PLANNING COMMISSION

Agenda Item No.: H.1
Date: October 22, 2013

Rural Residential Roadway Standards
Engineering Project No.: MISC 13-0008

REQUEST: Review the proposed Rural Residential Roadway Standards, which include a narrower roadway cross-section and lower lighting levels, as an alternative street design for rural residential areas and forward a recommendation to the City Council.

RURAL RESIDENTIAL ROAD SECTION

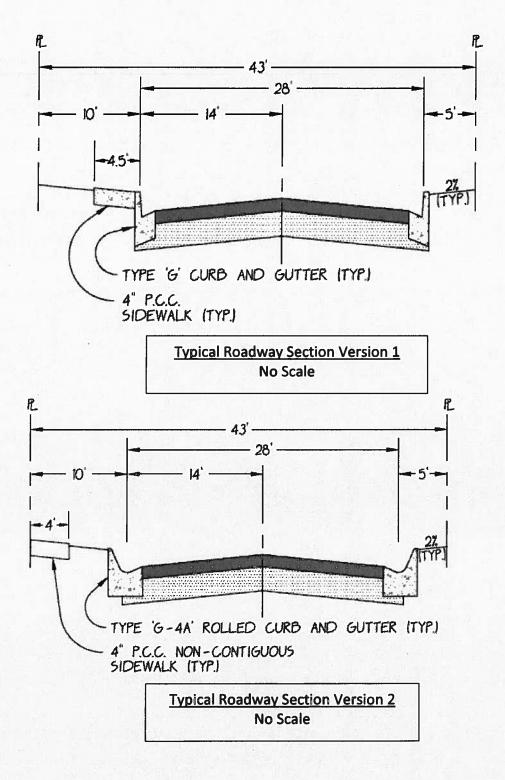
ON-STREET PARKING: On October 10, 2013, the Transportation and Community Safety Commission (TCSC) considered the two proposed rural standard road sections included in the TCSC staff report, which is attached. Note #3 indicates that on-street parking would not be provided. One Commissioner felt that visitors would park on the street occasionally when residents hosted large gatherings at their home, resulting in enforcement problems for the City. The TCSC continued the item and requested staff to bring back an enforcement plan.

Since the TCSC meeting, engineering staff had further discussions with the Fire Marshal regarding minimum lane widths for emergency vehicle access and potential conflicts with on-street parking. It was determined that the proposed 28-foot curb-to-curb road width would accommodate the 20-foot width required for emergency access and an 8-foot wide parking area along one side of the road. Note #3 would be revised accordingly.
